TECHNICAL INSTRUCTION

TITLE T65 'VEGA' Central Elevator Hinge on Tailplane, Elevator Tongue & Pivot Bearings for Elevator Rocker Arm.		T.I. No. 104/T65 Iss.2
CLASSIFICATION C.A.A. Mandatory		
COMPLIANCE Inspection to be carried out before the next flight unless LTO 'Elevator & Canopy Jettison Mechanism', 20th August has been carried out.		
OBJECTIVE To ensure structural integrity of the central elevator hinge on tailplane elevator drive tongue and to inspect the pivot bearings for the elevator rocker arm assy. Also to reinforce central elevator hinge on tailplane.		
JUSTIFICATION Cracking and a lack of stiffness has occurred in the area 'A' (Fig 1), the cause of which is attributable to heavy landings and/or excessive bearing loads during elevator assembly.		
APPLICABILITY All Slingsby T65A, C, D gliders, including spare tailplane/elevators expanding on CAA Airworthiness Directive No.008-08-82. (LTO 'Elevator & Canopy Jettison Mechanism', 20th August).

T.I. No. 104/T65 Issue 2

FIG 1 Area of Cracking on Vega T-Plane

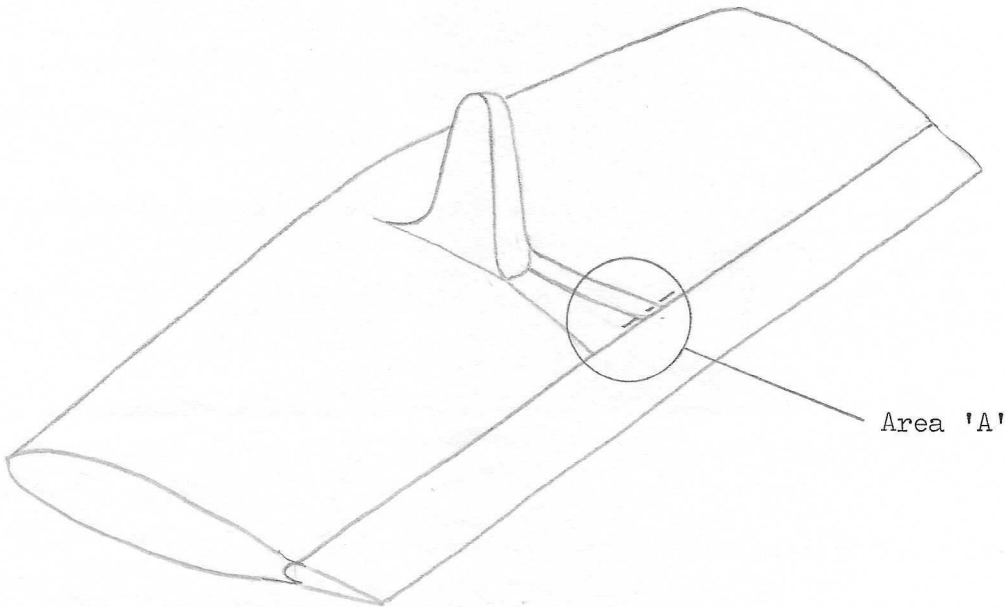
CONSEQUENTIAL LIMITATIONS If cracking is found on the tailplane central hinge the repair will require a new central tailplane rib (T65A-30-15) which must be fitted by S.A.L. or an approved repair shop before next flight.		
ACTION - Inspection to be carried out as follows : 1.1 With the tailplane/elevator assembly removed from the aircraft examine the glass reinforced plastic operating tongue of the elevator which projects forwards into the tailplane. The lips of this channel shaped tongue must be unbroken and continuous to the point where it merges with the elevator proper. Check the tongue for lack of stiffness in the vertical sense by attempting to bend the tongue with the fingers. If any degree of cracking, damage or abnormal flexibility is found it must be rectified before further flight in accordance with a repair detailed in Section 2. The preceding action must be carried out following a heavy landing or ground loop in addition to any other required inspections. 1.2 Inspect the pivot bearings (04 DU 04) for the elevator rocker arm assembly, on the top of the fin for wear. Any wear found in excess of 0.01" in the fwd & aft direction must be rectified before further flight. Fitting of the bearing is detailed in Section 3. 1.3 Inspect the tailplane centre hinge pin mounting rib at the section just forward of the hinge pin as detailed in Fig 6. If cracks or damage are found a repair entailing the fitting of a new 'reinforced' rib will be required. The repair scheme is detailed in Section 4 and should be undertaken by S.A.L. or an approved repair shop. If the section does not show signs of cracking a reinforcement cloth will be required as detailed in Section 5. Alternative means of repair for minor cracking may be carried out with the agreement of SAL. <u>Note</u> - Use Epikote 162/Epikure 113 resin system throughout.

FIG 2 Reinforcement of Elevator-Tongue

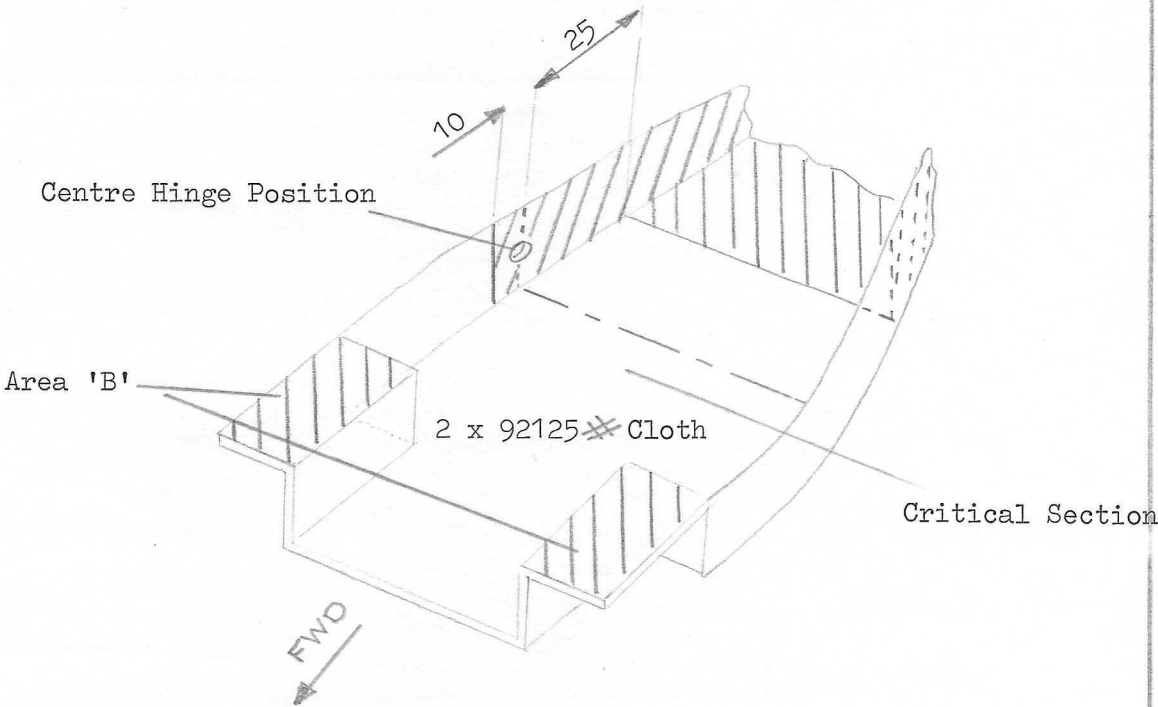
- 2.1 Rectification of lack of stiffness of the elevator tongue will be as follows :-
- (a) Remove the tailplane/elevator assembly from the aircraft.
 - (b) With the elevator removed from the tailplane, abrade the tongue of the elevator over the area detailed in Fig 2.

- (c) Layup 2 layers of woven roving cloth (2 x 92125~~XX~~) over the area detailed in Fig 2.
- 3.1 If the pivot bearing 04 DU 04 is worn it may be replaced as follows (refer Fig 3).

- (j) When fitting the tailplane elevator assembly ensure the elevator tongue seats correctly on the actuator. If there is a clearance between the tongue and actuator the tongue must be built up in the Area 'B' detailed in Fig 2. If there is a foul between the tongue and actuator, the tongue must be trimmed (refer Area 'B' Fig 2) to seat properly on the actuator. Build up the cloth under the flanges and around the web, to compensate for any cloth removed.

Only layup cloth on the inside of the tongue on the area NOT shaded.

FIG 3 Actuator Pivot Bearing

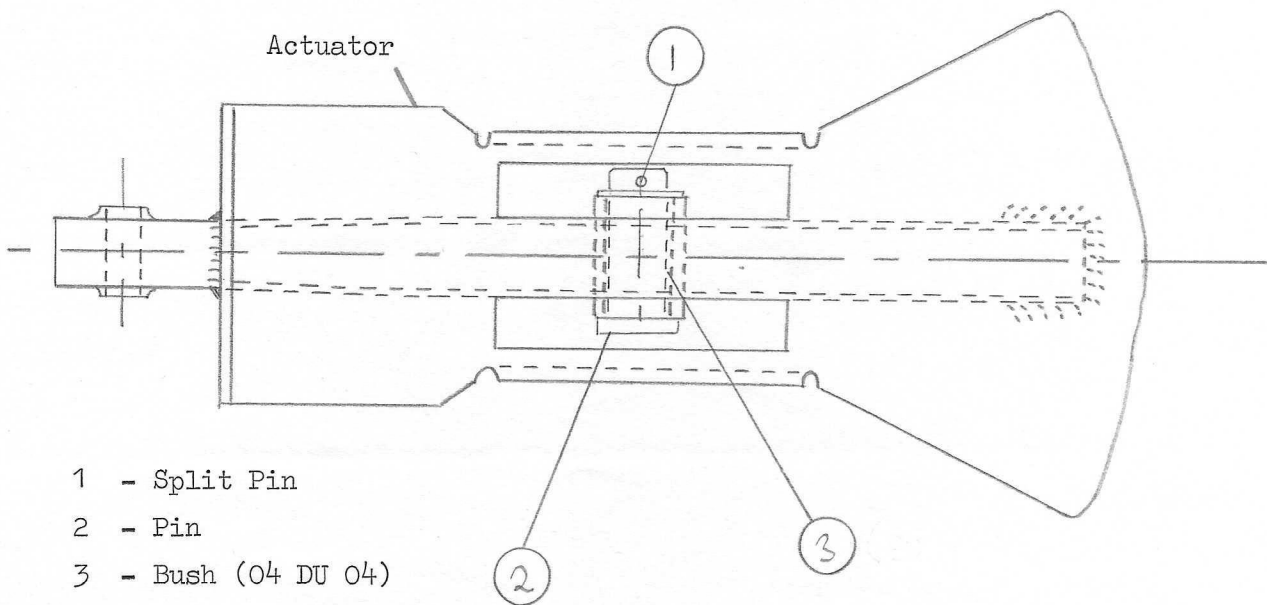
- (a) Remove the tailplane/elevator assembly from the aircraft.
 - (b) Remove the split pin (Item 1) and washer from the central hinge of the actuator (located on top of fin).

- (c) Remove pin (Item 2).
 - (d) Disconnect the pushrod on the fwd end of the actuator (similar to above).
 - (e) Drift the bush from the elevator actuator assembly and replace with new bush (04 DU 04), available from S.A.L.

FIG 4 View of Central Section of T.Plane with the top skin removed.

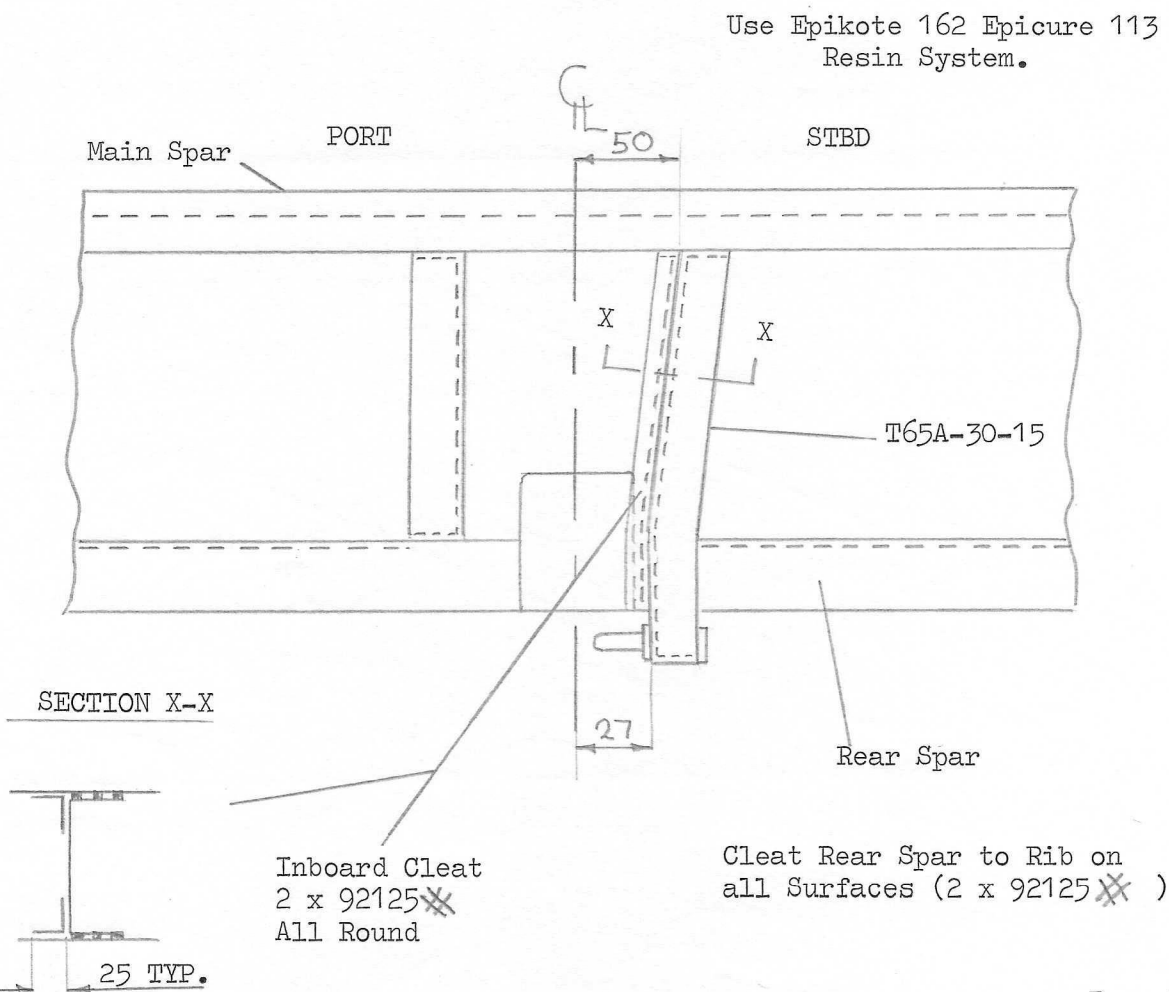
- (f) New split pins must be fitted when reassembling.
- 4.1 Replacement of the central tailplane rib with reinforced rib only available from S.A.L. will be carried out as follows (Refer Fig 4).

- (e) Coat the rib with glassflock and initially position the rib to the dimensions detailed in Fig 4.
 - (f) Position the tailplane in tressles as shown in Fig 5.

- 4.1 (g) Fit the elevators checking the split pin hole is accessible. The rib should now be correctly positioned.
- (h) Carefully remove the elevators and apply the cleat cloths as detailed in Fig 4.

FIG 5 Positioning of Elevators

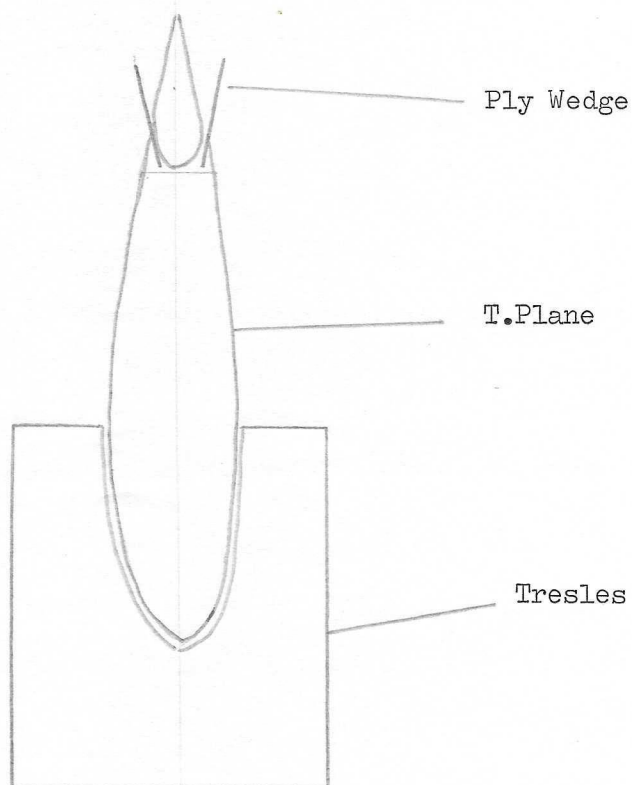
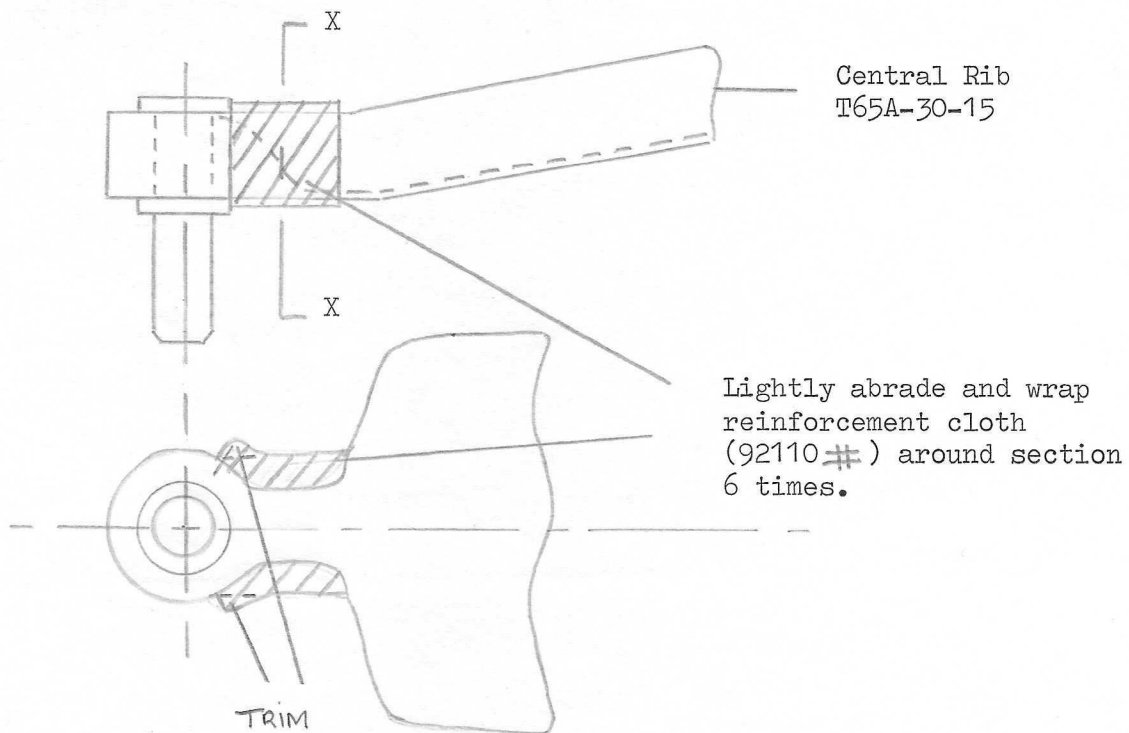
- (i) The elevators should now be repositioned to ensure the rib is still located in the correct position. The elevators should be pushed fully home again ensuring the split pin hole is accessible. Position wedges as shown in Fig 5 to hold the elevators in the neutral position.
